# Ryan Information Bulletin

**Product Type: Lawnaire 28**

**Bulletin No: C-042-04**

## Tine Arm Welds

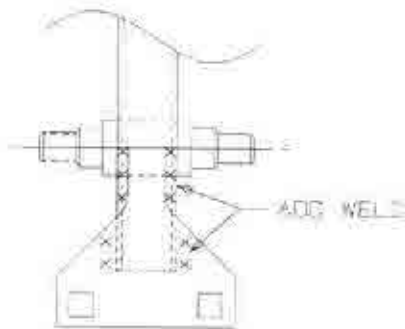
It has come to our attention that part number 547509.7 might be welded incorrectly.

Need to inspect part number 547509.7 to see that the tine arm is welded as shown. If not you will need to have the tine arm welded on both sides at the "x".
